Re: Source Materials License SUA-1534
Docket No. 40-8943
Mine Unit 1 Restoration; Response to Request For Additional Information

**Crow Butte Resources, Inc.
Response to U.S. Nuclear Regulatory Commission
Request For Additional Information**

Mine Unit 1 Groundwater Restoration Completion

Crow Butte Uranium Project

Figure 1
Reduction of Uranium per Pore Volume Treated

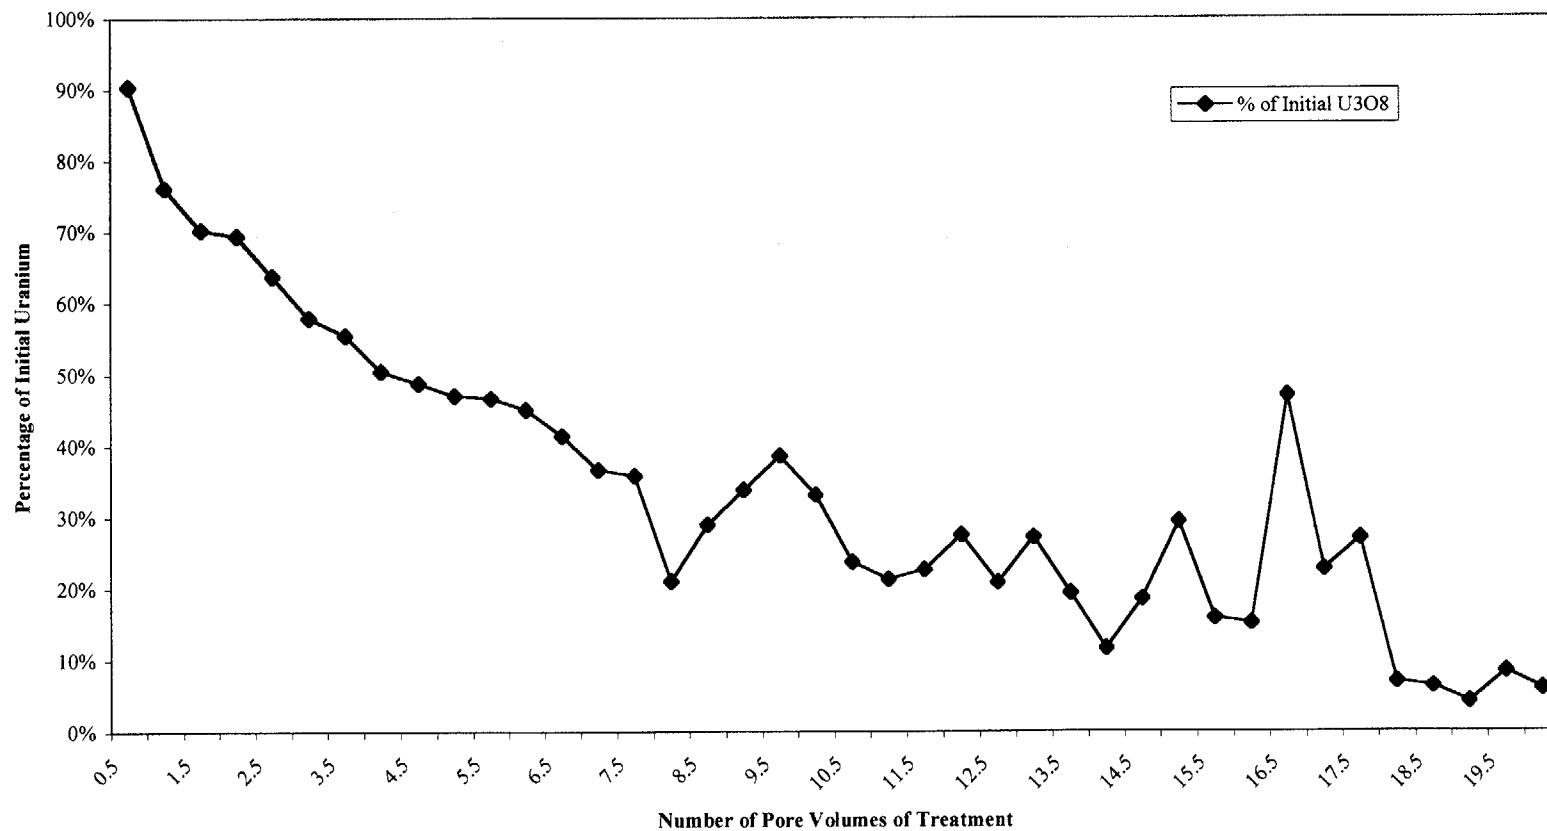
Recognizing that the treatment processes employed are not 100 percent effective, a point will be reached during treatment when additional efforts will result in minimal improvement in the water quality. Restoration efforts in Mine Unit 1 proceeded beyond the point where significant improvement was possible with continuing treatment. To illustrate this, Figures 1 and 2 contain summary data for the restoration patterns that compares the percentage of reduction of uranium and conductivity from the initial, post-mining concentration with the total number of pore volumes processed during groundwater treatment. From these graphs, it is apparent that further processing quickly loses effectiveness after the initial pore volumes.

Figure 3
Mine Unit 1
Monitor Well Locations

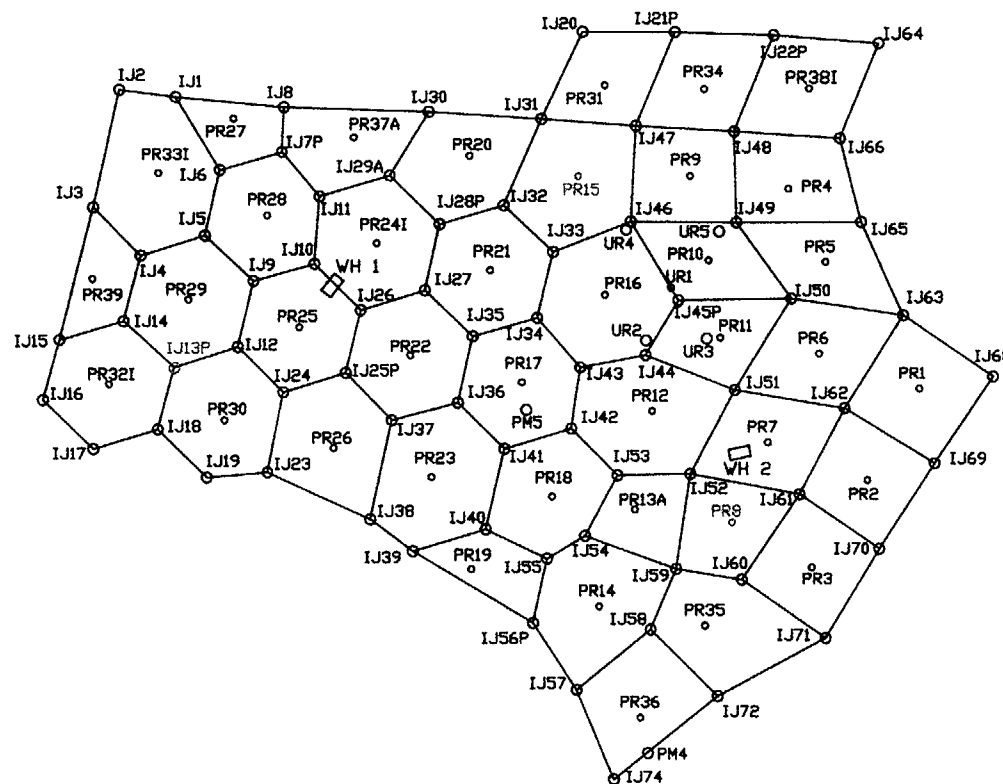
To provide additional data supporting the assertion that Mine Unit 1 is relatively stable, CBR has summarized monitoring data for three Mine Unit 1 baseline restoration wells that have been sampled routinely since the stabilization period. These wells were designated as perimeter monitor wells in December 1999 following the approval of the Mine Unit 1 restoration by the NDEQ. The three wells (PR-8, PR-15 and IJ-13) were selected to serve as perimeter monitor wells for Mine Units 2 and 3 and are evenly distributed in Mine Unit 1. Figure 3 shows the location of these three wells within Mine Unit 1.

Figure 4
Mine Unit 1 Average Monitor Well Trends

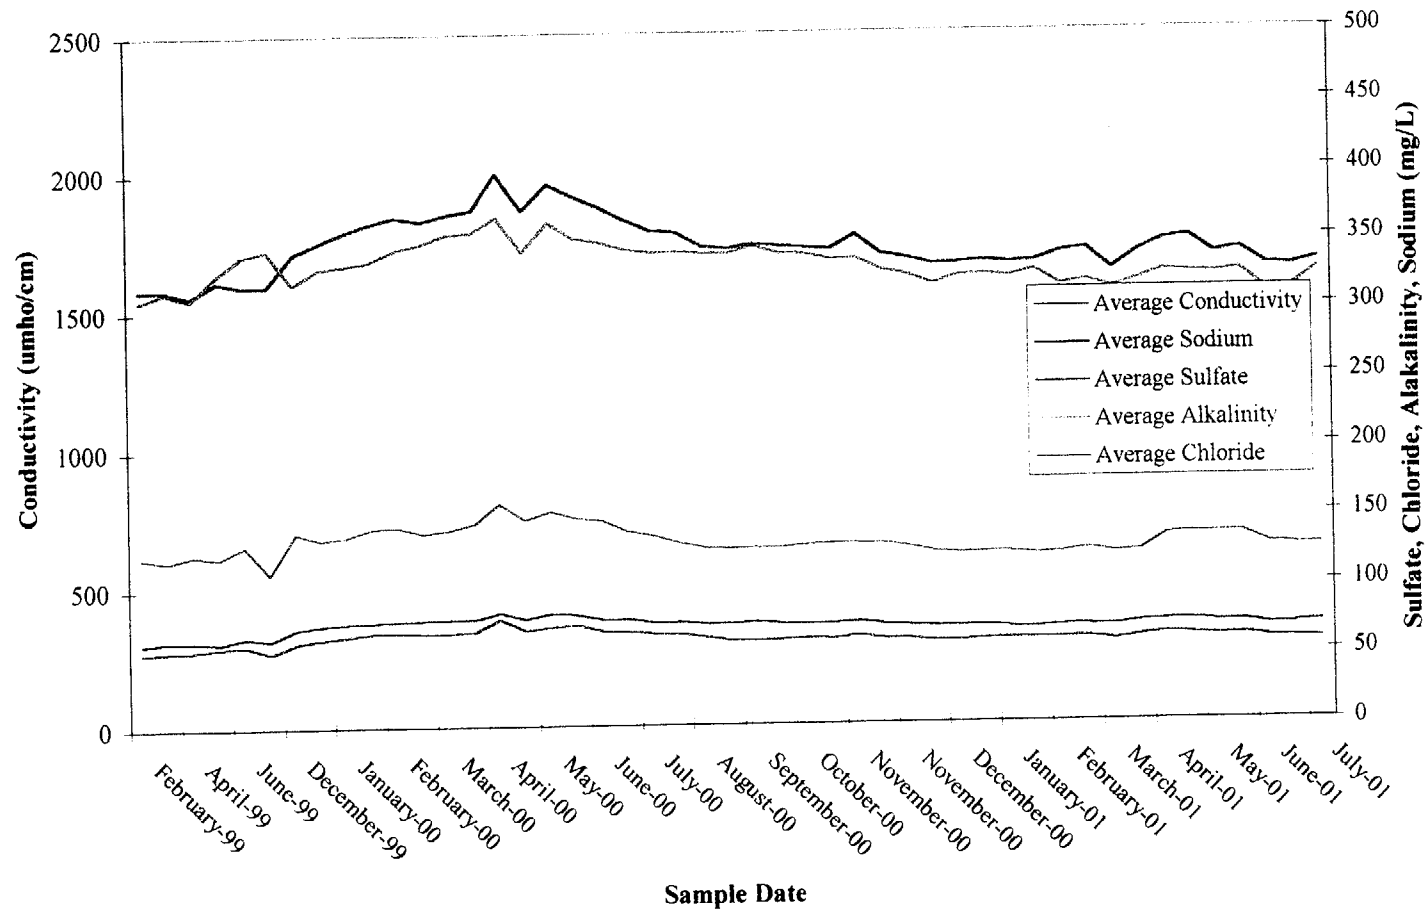
Figure 4 provides the results of the stabilization monitoring from February through July 1999 and the biweekly excursion monitoring from December 30, 1999 through July 12, 2001 for PR-8, PR-15, and IJ-13, showing trends during this period for all five excursion parameters. The individual data for each monitored constituent was averaged for the three wells in accordance with the restoration goals (i.e., mine unit average). Note that there were no samples obtained during the period between the end of the stabilization period in July 1999 and the initial excursion monitoring following NDEQ approval of Mine Unit 1 restoration in December 1999.

The data for the 29-month period indicates no increasing trend for any of the monitored constituents. The complete monitoring data and individual trend graphs for each parameter are included in Appendix B. Note that the individual trend graphs also show the baseline concentration for reference purposes. With the exception of alkalinity, all parameters are below the baseline average for the parameter of interest. Average alkalinity concentrations have been approximately 13 percent above baseline during the period, but no strong trends are exhibited.
